STORAGE BACK OF AC

OVERVIEW

11031691 REAR HEAT/AC STORAGE, 3 EMS GLOVE HOLDERS

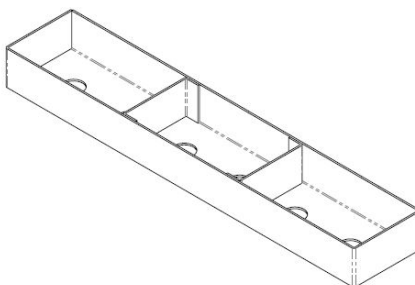
The Sales Department would like to inform the dealer network that the standard 11031690 STORAGE COMPT, BACK OF HEAT/AC UNIT option has been discontinued, and the following options have taken its place. We hope this adds further clarity for the dealer network, and production on storage options mounted on the back of the AC unit. Please refer to the images with the new options below. These images can also be found in SQS2 by clicking on the question mark icon next to the option.
